123202

D06-ITS MAINT-FY2026

WO 1.6
MEDIAN JUNCTION BOXES, VARIOUS LOCATIONS

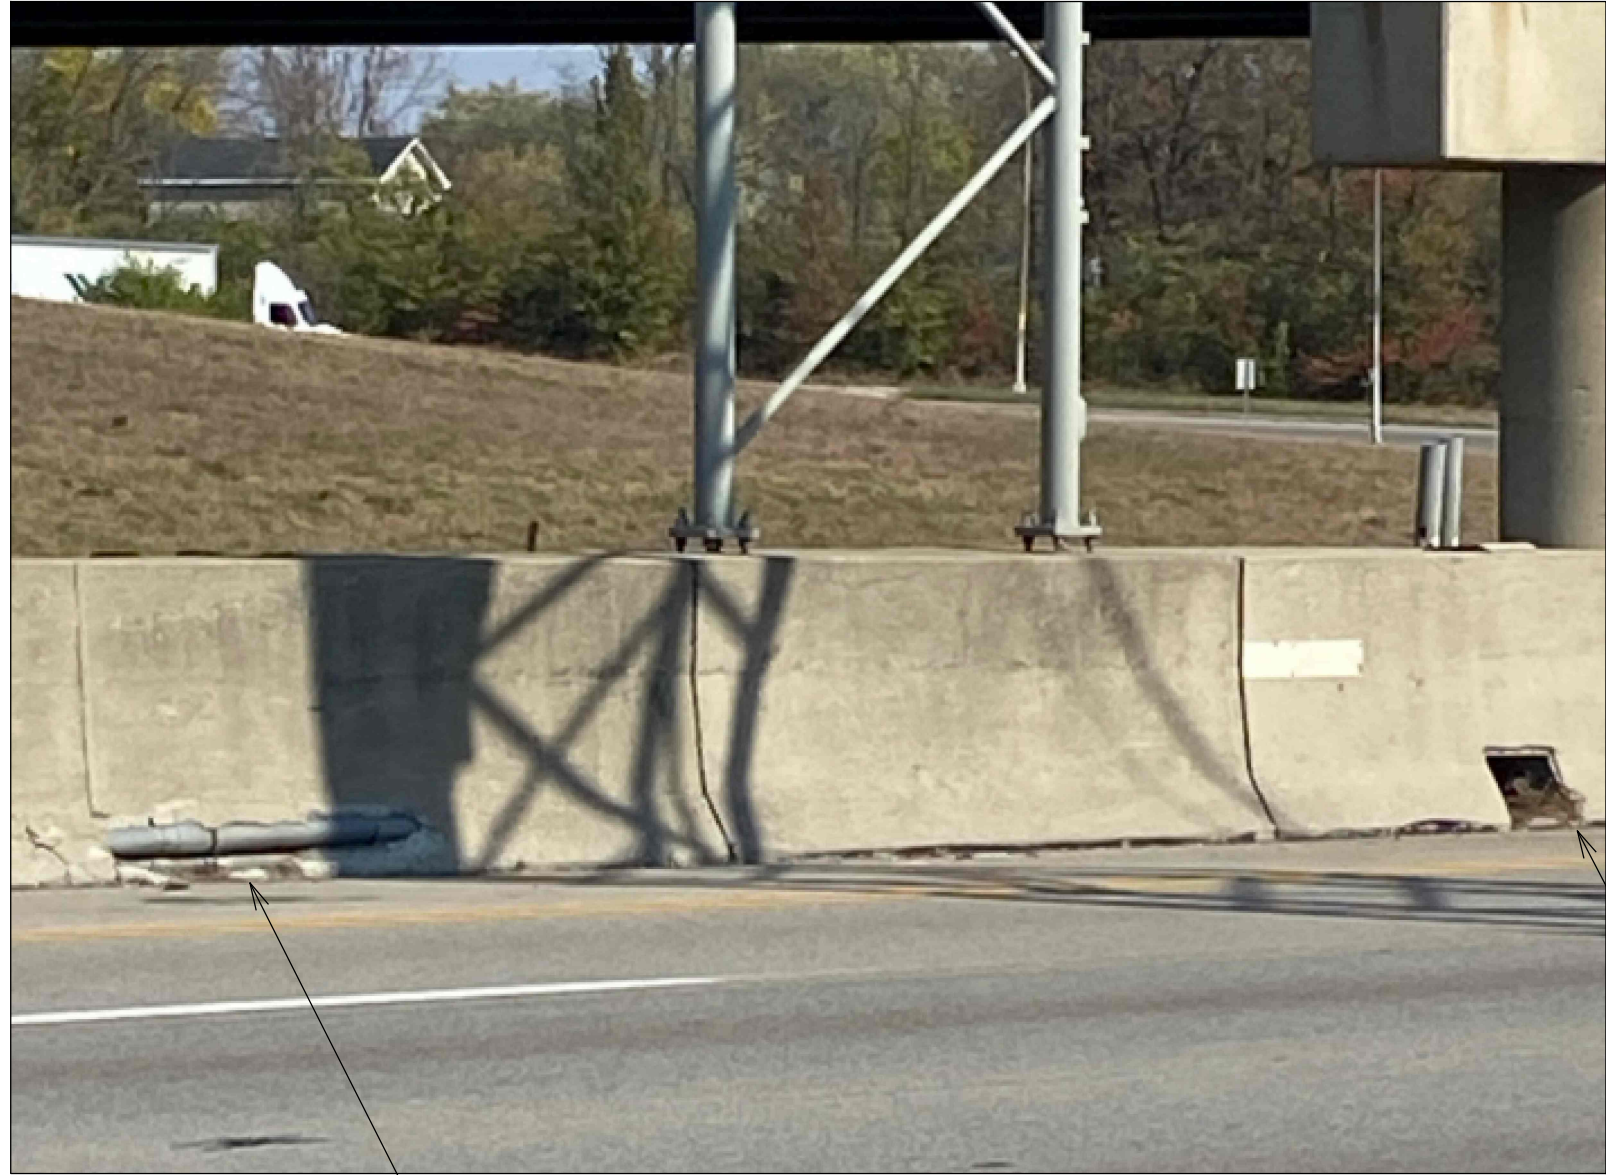
NOTE ADDED

SHEET TITLE
UPDATED

I-70 MEDIAN JUNCTION BOX LOCATIONS					
	STATE LOG MM	DIRECTION	LATITUDE	LONGITUDE	WORK REQUIRED
MB-1	93.95	EB	39.974848	-83.100125	WALL REPAIR, EX. CONDUIT EXPOSED
JB-1	93.96	EB	39.974854	-83.100114	JUNCTION BOX LID AND REPAIR
JB-2	94.76	EB	39.973813	-83.085535	JUNCTION BOX LID AND REPAIR
JB-3	95.68	EB	39.969851	-83.069525	JUNCTION BOX LID AND REPAIR
JB-4	104.30	EB	39.934416	-82.934267	JUNCTION BOX REPAIR
JB-5	104.45	EB	39.932799	-82.932357	JUNCTION BOX REPAIR
JB-6	104.63	WB	39.9319	-82.929214	JUNCTION BOX LID AND REPAIR

SEE NOTE ON P.2 FOR ITEM 625 - MEDIAN JUNCTION BOX, AS PER PLAN.
